F3 Freeway to Branxton link

Independent Design Review: Conditions of Approval 53 and 54

**AusLink National Network
F3 to Branxton link**

**Independent Design Review
Conditions of Approval 53 and 54**

Figure 15 Buchanan interchange alternative location vegetation changes

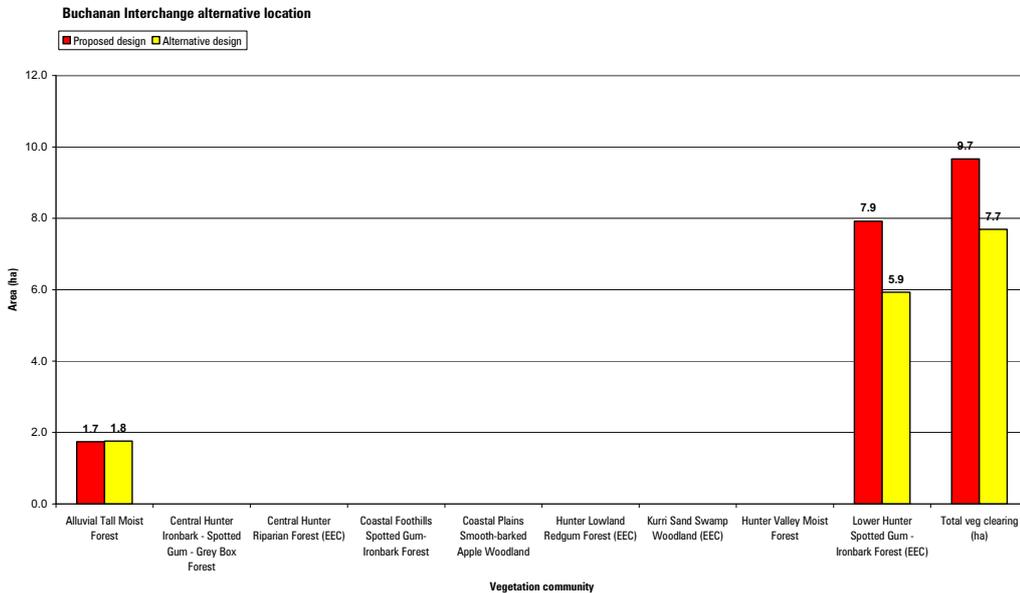
The Buchanan interchange could be moved from its present location into the Wallis Creek floodplain west of Wallis Creek. Figure 15 shows that the alternative design change would be likely to reduce the amount of vegetation that would require clearing as the Buchanan interchange would be located within already cleared farmland.

The alternative design change appears feasible from an engineering perspective. The new interchange type is more desirable as it provides free flow arrangement for all movements.

However, the new location of the interchange is less desirable as it does not coincide with the intersection point of John Renshaw Drive and the Link, and it decreases the distance to the Kurri Kurri interchange.

Figure 16 Buchanan to Kurri Kurri alternative alignment vegetation changes

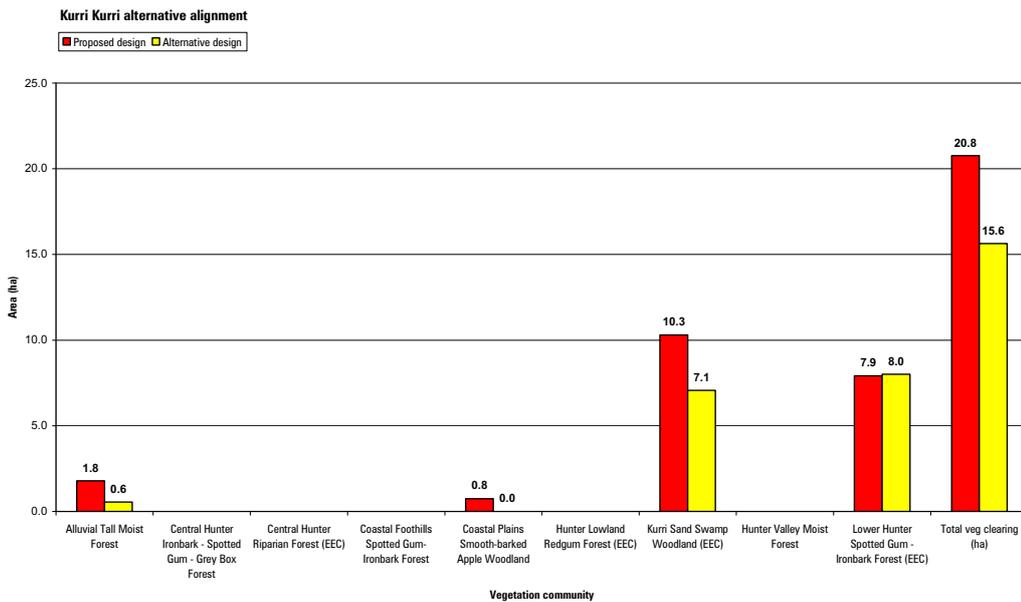
The alternative design change would affect poor quality Alluvial Tall Moist Forest, Kurri Sand Swamp Woodland and Lower Hunter Spotted Gum – Ironbark Forest. It is poor quality because it has been previously logged, the mid-storey is sparse and ground cover is limited. It is also transected by tracks and easements and is subject to rubbish dumping. Figure 16 shows that the alternative design change would have a positive ecological outcome because it would reduce clearing.

The alternative design change appears feasible from an engineering perspective.

Figure 17 Buchanan to Kurri Kurri alignment and interchange location vegetation changes

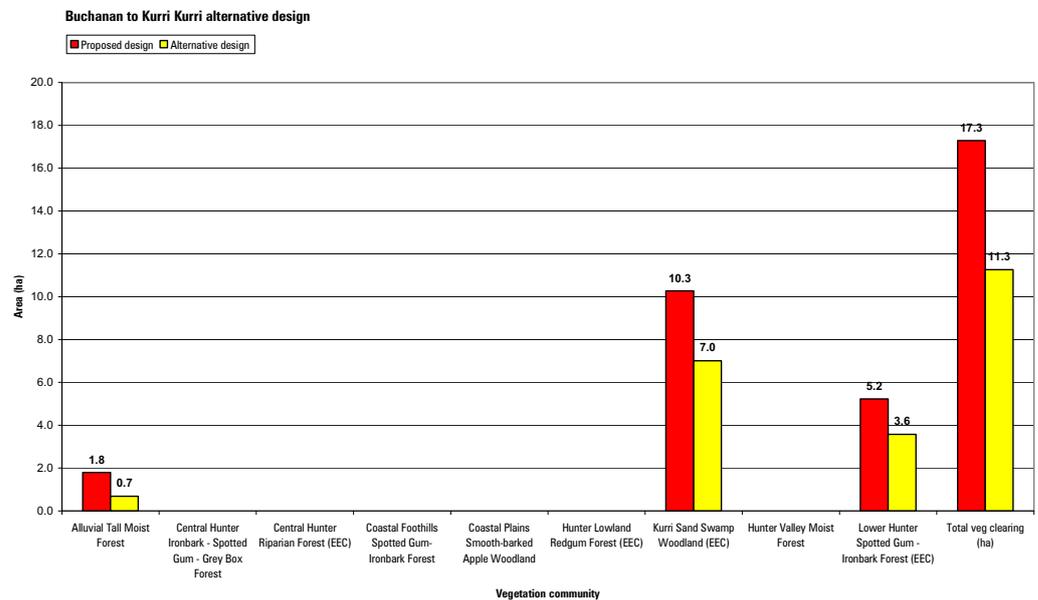
The alignment of the Link could be moved to the northeast between the Buchanan interchange and the Kurri Kurri interchange, generally as discussed in Section 4.2. The alternative alignment could be combined with the relocation of the Buchanan interchange, as discussed in Section 4.1. The benefit of these two design changes would be to further decrease vegetation clearing described in Sections 4.1 and 4.2. These sections also provide a description of the threatened species and communities that would be affected by this alternative design, including the quality of habitat. Figure 17 shows that the proposed design change would have a positive ecological outcome because it would reduce clearing.

However, the new location of the interchange is less desirable as it does not coincide with the intersection point of John Renshaw Drive and the Link, and it decreases the distance to the Kurri Kurri interchange.

The overall road geometry appears acceptable, although the vertical geometry in the Kurri Kurri interchange vicinity is less desirable.

Figure 18 Allandale Quarry alternative alignment vegetation changes

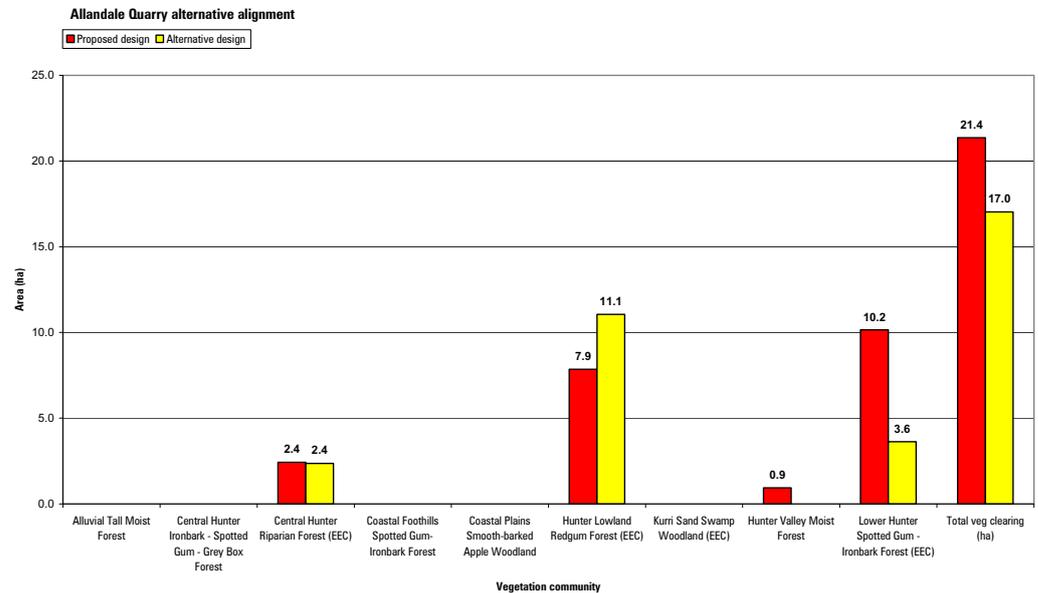
No threatened plant species were recorded within the footprint of the alternative design change. However, Central Hunter Riparian Forest (as part of River-flat Eucalypt Forest), Hunter Lowland Redgum Forest and Lower Hunter Spotted Gum-Ironbark Forest, which are all EECs under the TSC Act, would be affected. No threatened animal species have been detected in the vicinity of the Allandale Quarry, although Squirrel Gliders have been located on the route further to the north near Camp Road (Connell Wagner 1997, DEC Atlas of NSW Wildlife). Figure 18 shows that the alternative design change would have a positive ecological outcome because it would reduce clearing.

When the RTA was developing route corridors for the Link in the early 1990s, an alignment was considered that was closer to the Allandale Quarry than the concept design. However, following extensive consultation with the quarry operator, the RTA agreed to move the alignment to the north to provide greater separation and vegetative screening between the quarry and the Link. The amended alignment was exhibited with the EIS in 1995 and included in the concept design which was approved by the Minister for Planning in 2001. The detailed concept design also adopts this alignment.

Figure 19 Branxton interchange alternative location vegetation changes

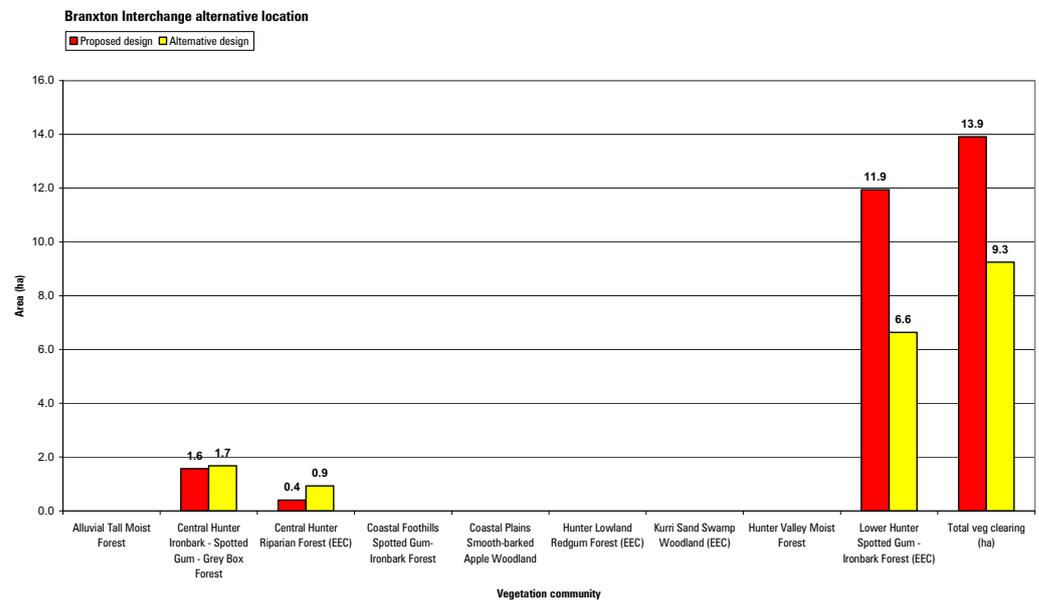
Both the proposed and alternative design changes would affect a significant area of moderate quality Lower Hunter Spotted Gum-Ironbark Forest and Central Hunter Ironbark - Spotted Gum-Grey Box Forest, and a small patch of poor quality Central Hunter Riparian Forest along Anvil Creek. Although cleared pastures, roads and a railway already fragment this habitat, it provides a string of forest refugia in what is a mostly cleared area. Figure 19 shows that the alternative design would have a positive ecological outcome when compared to the proposed design change because it would reduce clearing.

The alternative change appears feasible from an engineering perspective. The overall road geometry appears acceptable.
